Access Compliance Report

Public Rights-of-Way

Intersection ID: 10016113	Main Street: N_SHARON_AMITY_RD	Cross Street: N/A	Location: E
ADA ID: AF7D5225F1E5	Ramp Type: Perp	Initial Pass/Fail: Fail	Overall Compliance: No
		Severity Score: 12.5

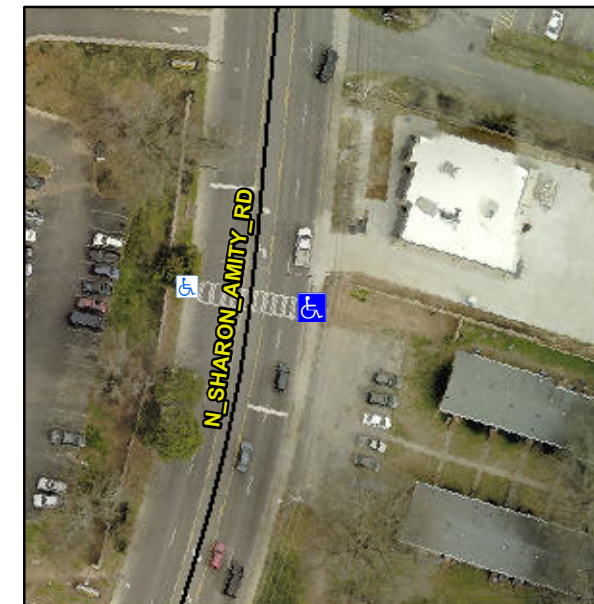
Not Found, R304.2.2

Compliance	Description	Data	Compliance	Description	Data
N/A	Ramp Length (in)	59.0	No	Ramp Slope (%)	8.8
Yes	Ramp Width (in)	48.0	Yes	Ramp XSlope (%)	1.3
N/A	Flare Type LT	N/A	N/A	Flare Type RT	N/A
N/A	Flare Slope LT (%)	N/A	N/A	Flare Slope RT (%)	N/A
N/A	Flare Traversable LT?	N/A	N/A	Flare Traversable RT?	N/A
N/A	Landing Length (in)	N/A	N/A	DWS Provided?	N/A
N/A	Landing Width (in)	N/A	N/A	DWS Contrast?	N/A
N/A	Landing Slope (%)	N/A	N/A	DWS Length (in)	N/A
N/A	Landing X Slope (%)	N/A	N/A	DWS Full Width?	N/A
N/A	Landing Curb? (Y/N)	N/A	N/A	DWS Offset (in)	N/A
N/A	Shared Landing?	N/A			
N/A	Gutter Ponding?	N/A	N/A	Gutter Slope (%)	N/A
N/A	Gutter Lip Ht (in)	N/A	N/A	Gutter X Slope (%)	N/A
N/A	Painted X Walk1?	Yes	N/A	Painted X Walk2?	N/A
	X Walk 1 Direction	To W		X Walk 2 Direction	N/A
N/A	X Walk 1 Width (in)	114.0	N/A	X Walk 2 Width (in)	N/A
	X Walk 1 Slope (%)	0.7		X Walk 2 Slope (%)	N/A
	X Walk 1 X Slope (%)	2.0		X Walk 2 X Slope (%)	N/A

Remove & Replace Entire Ramp.
